**STATE OF HAWAII
DEPARTMENT OF TRANSPORTATION
HARBORS**

**ADDENDUM NO. 1
FOR
REPAIR ELEVATOR AT ALOHA TOWER
HONOLULU HARBOR, OAHU, HAWAII
S10842R**

October 11, 2024

2 11TH FLOOR POWER PLAN
 E-5 SCALE: 1/4" = 1'-0"

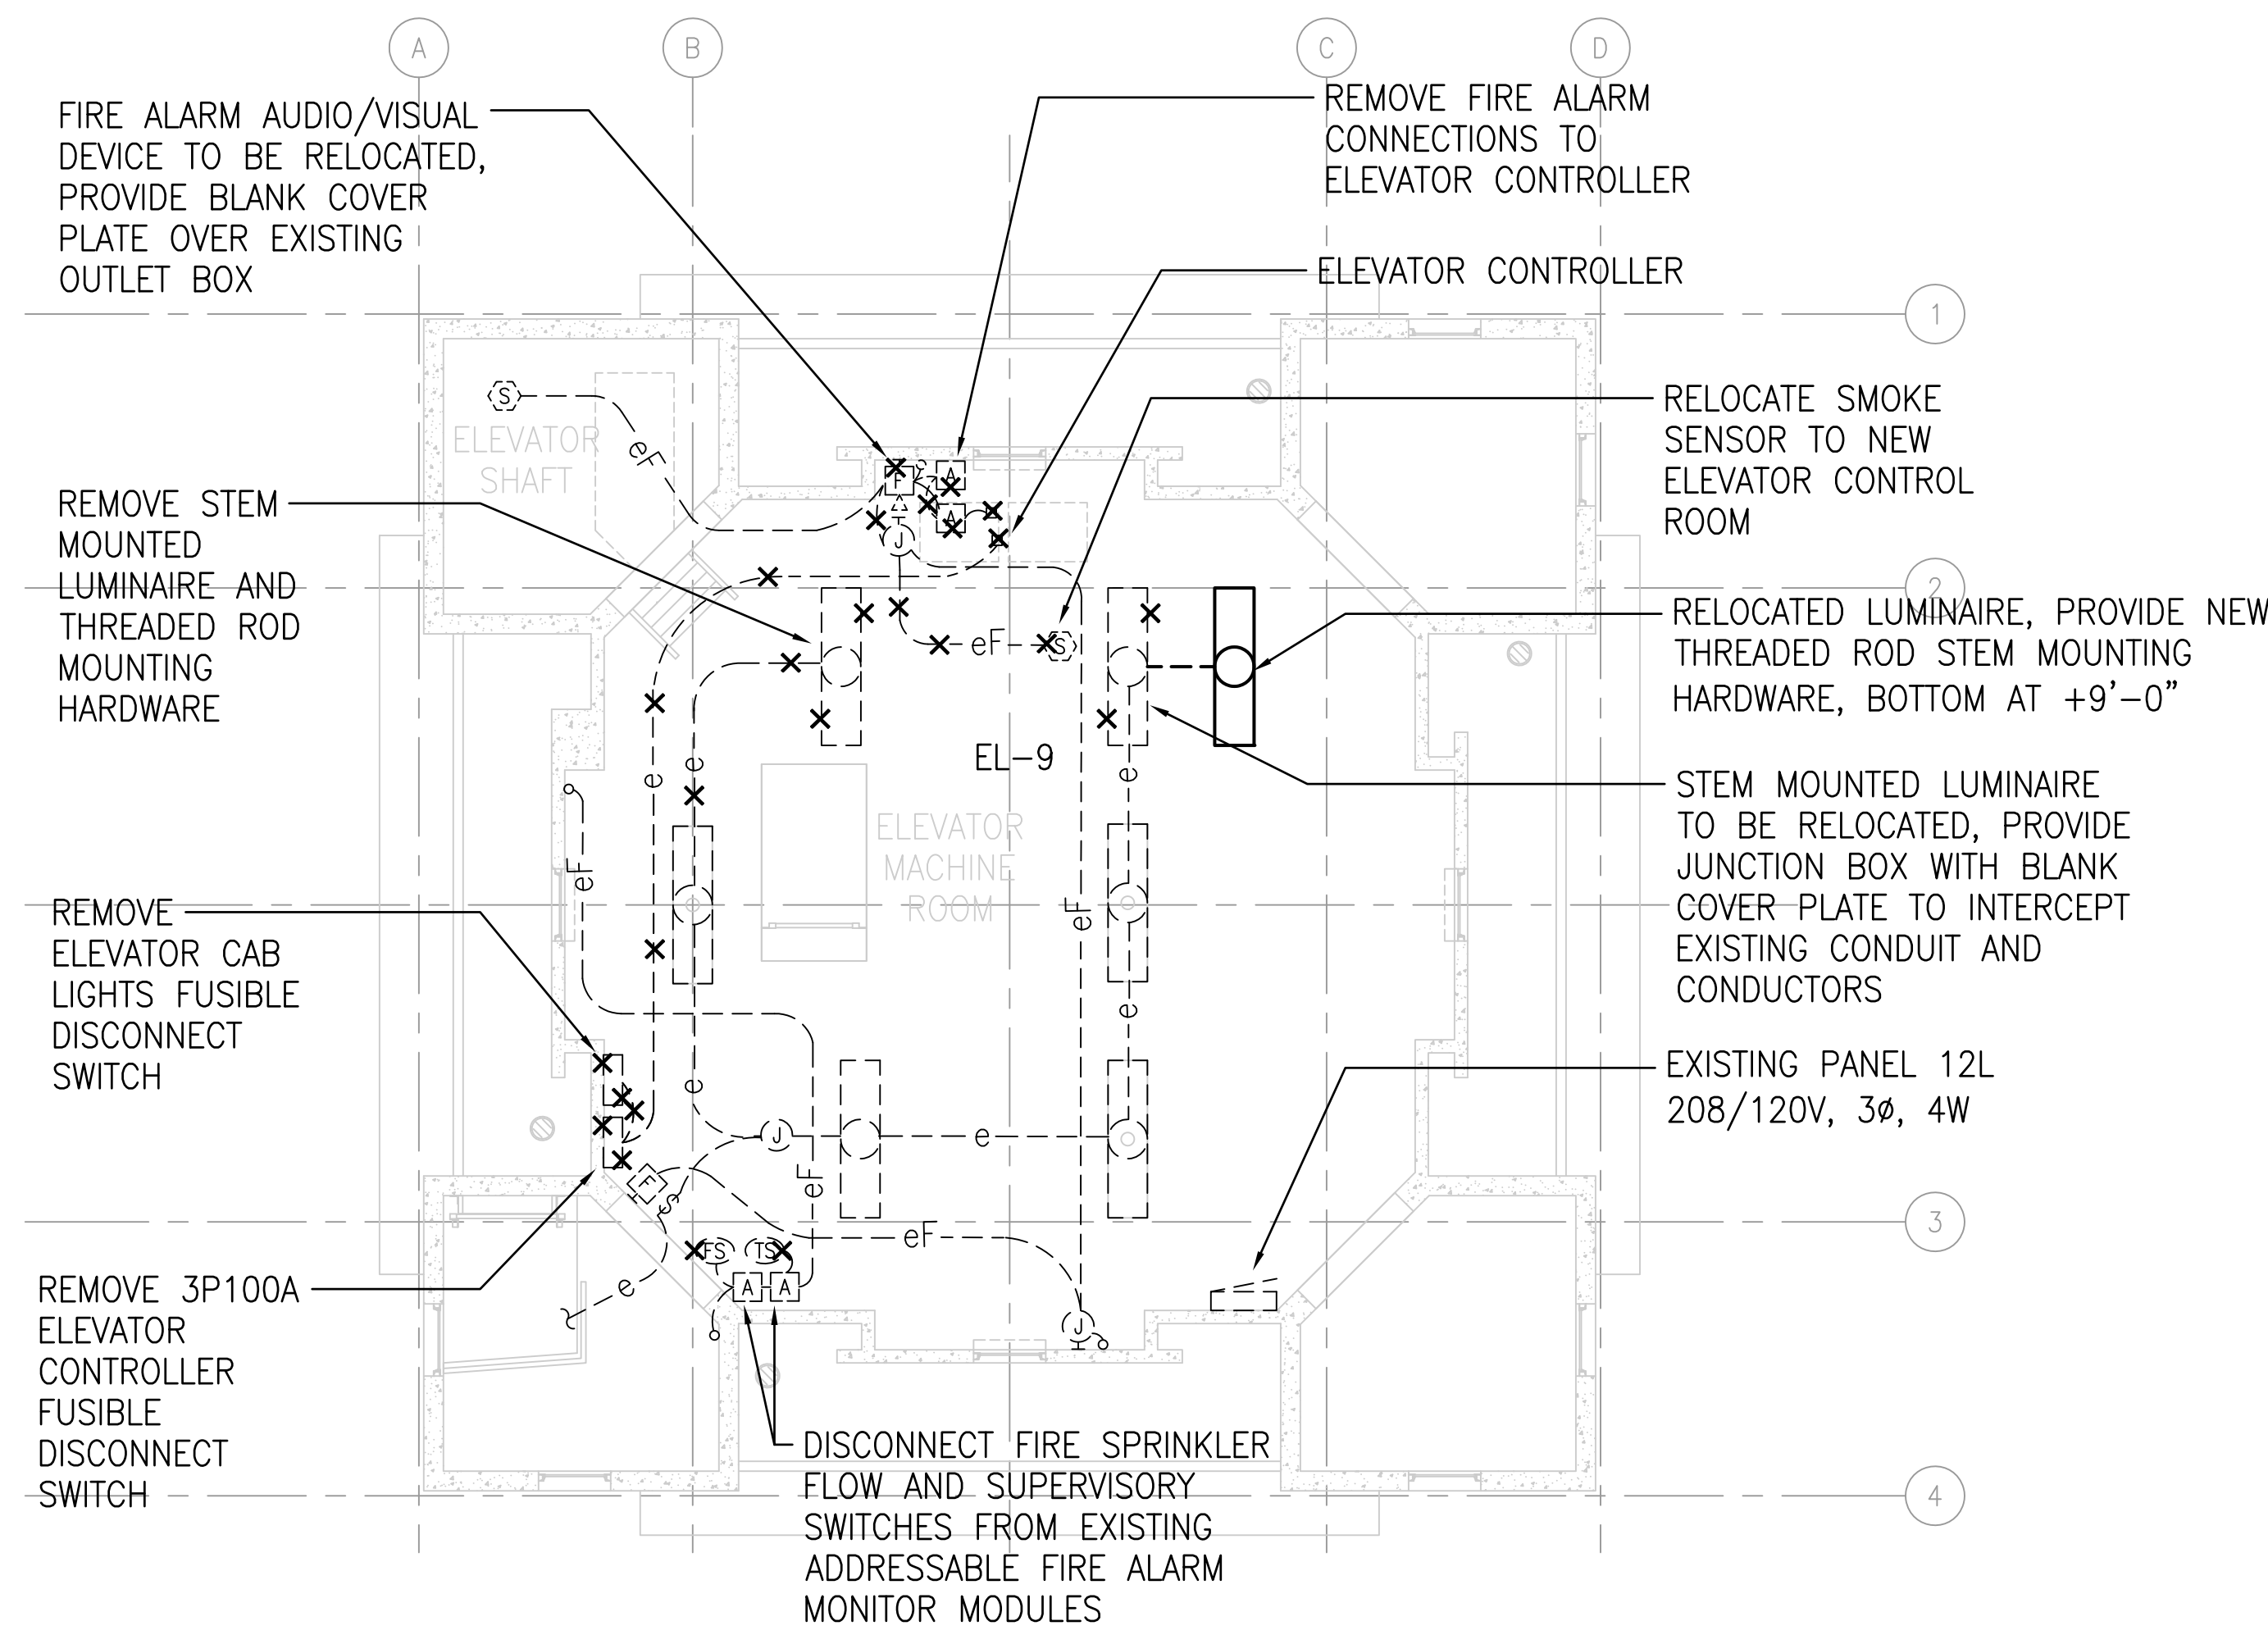
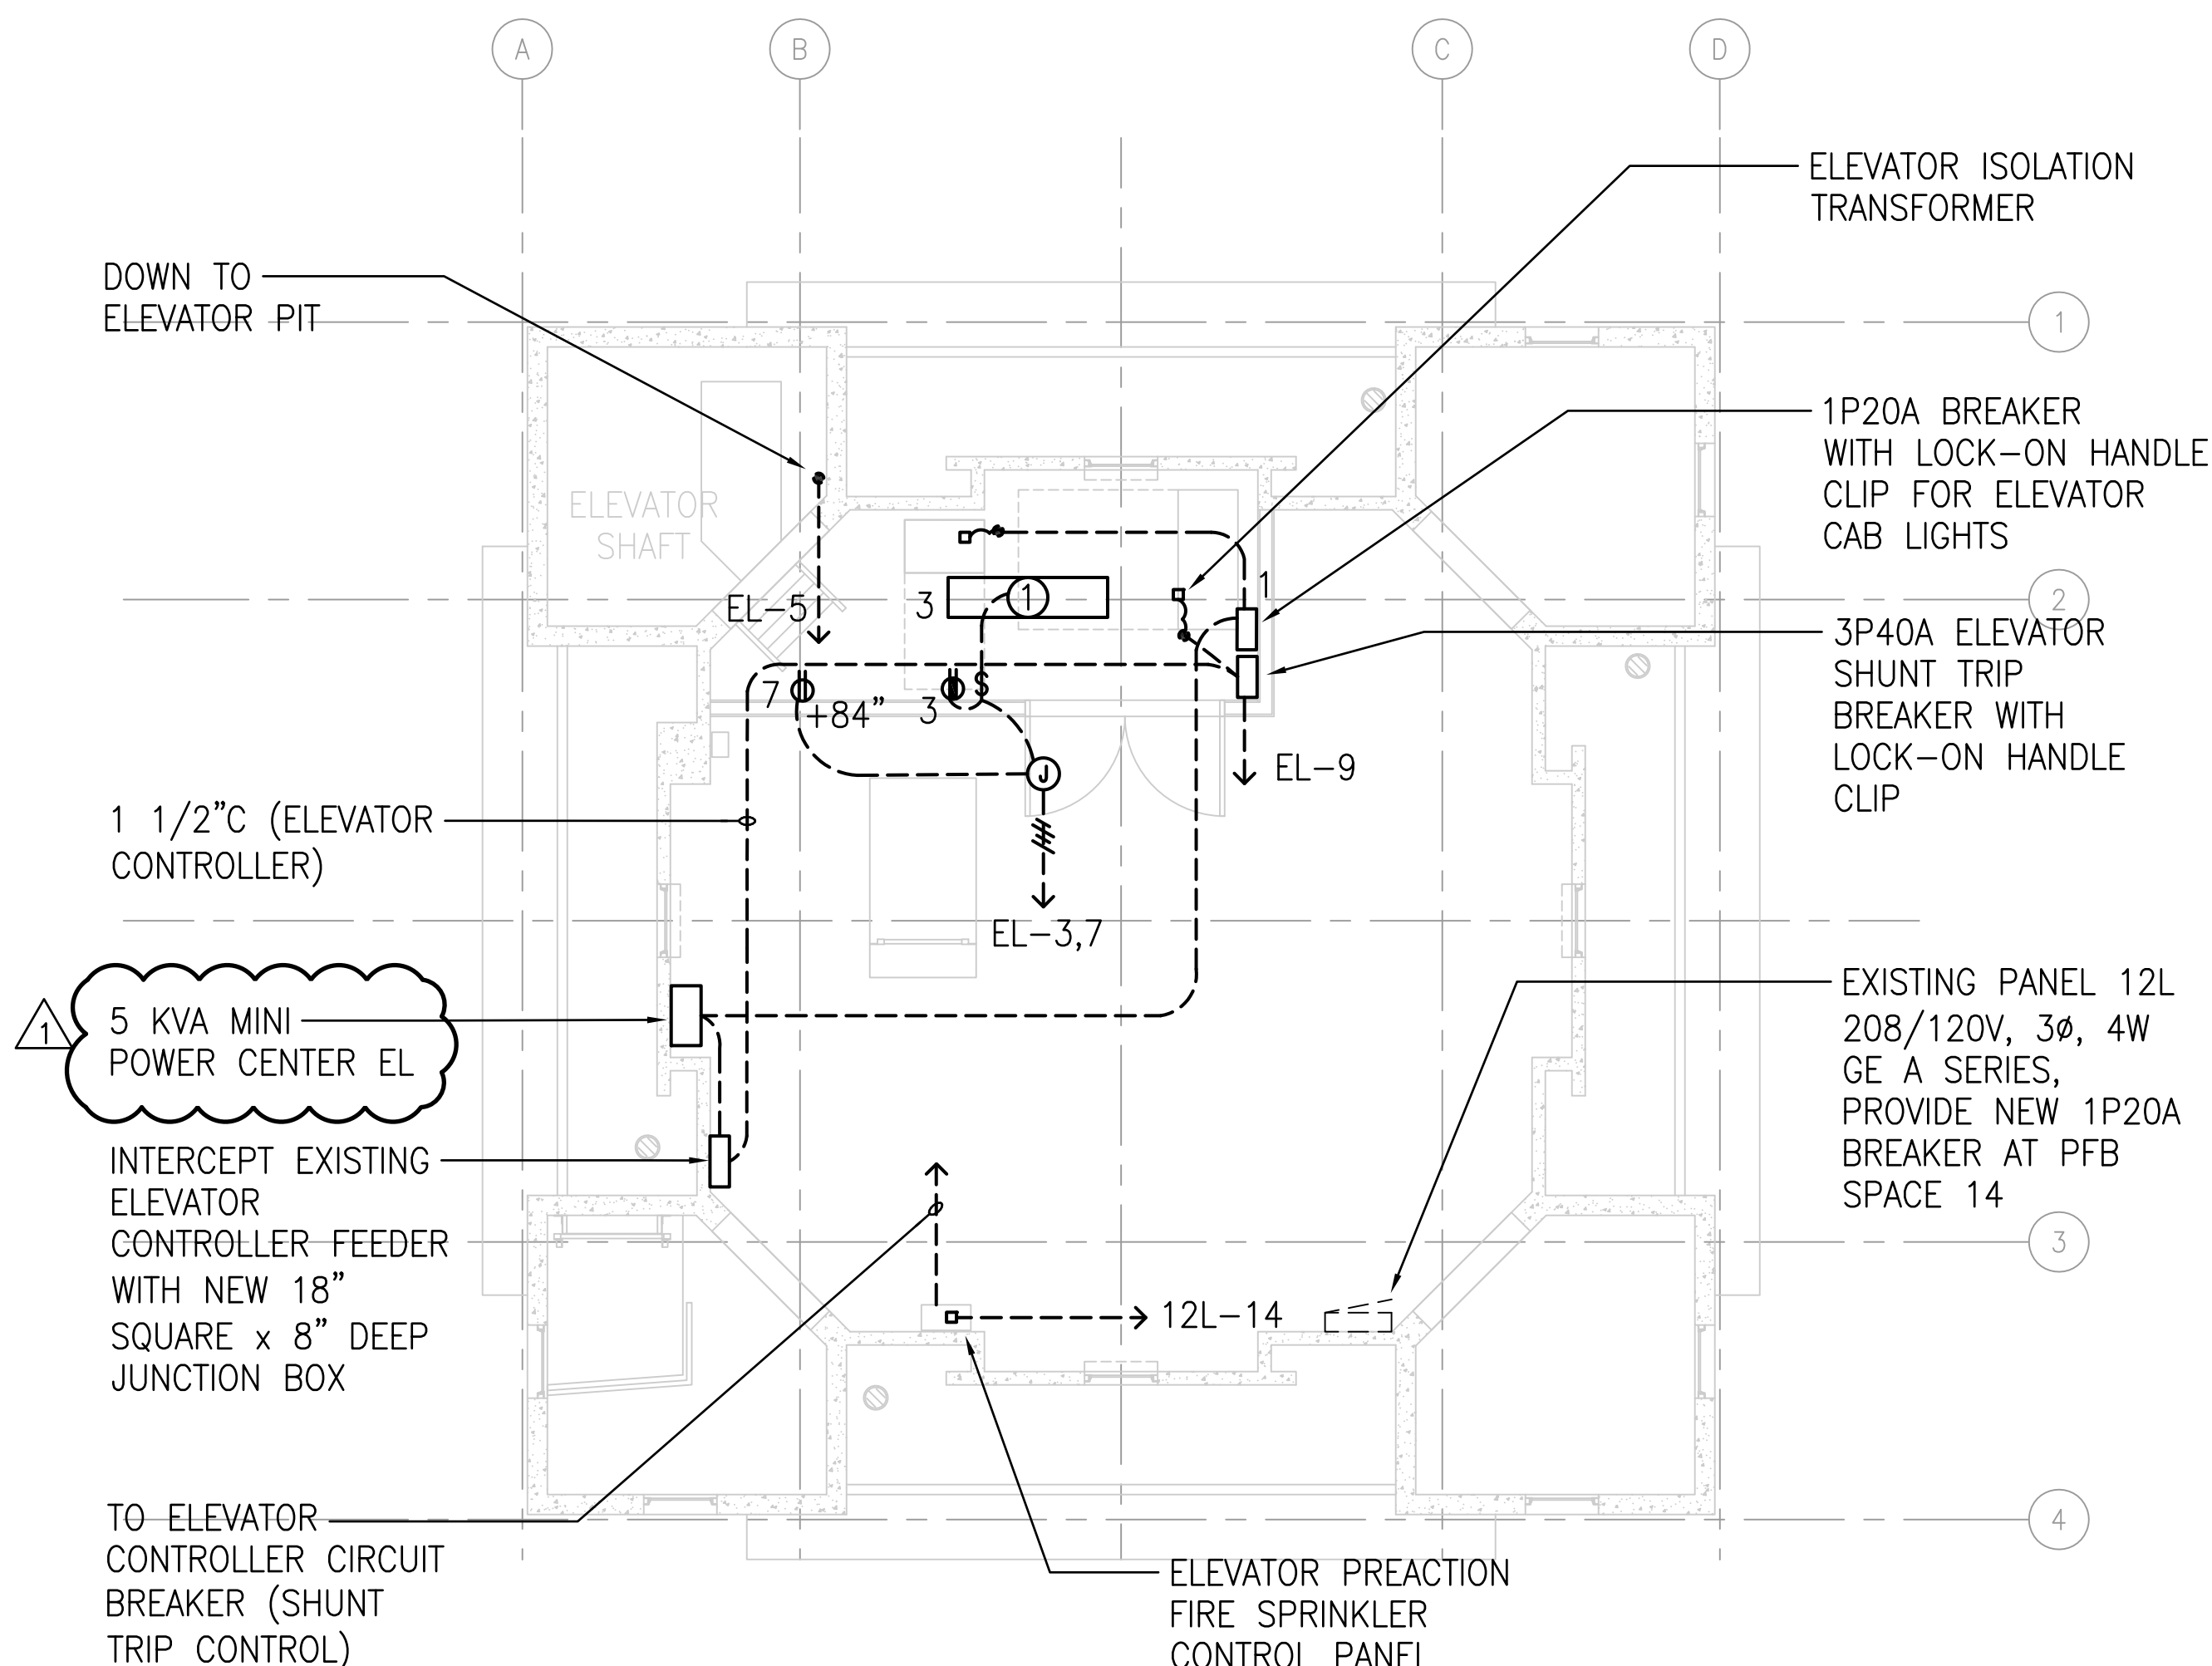
16. Detail 2/E-5 shows a new 3kVA mini-power center EL. One-line diagram detail 1/E-6 shows a 5kVA mini-power center EL. Please clarify.

Response: Mini power center shall be rated 5 KVA.
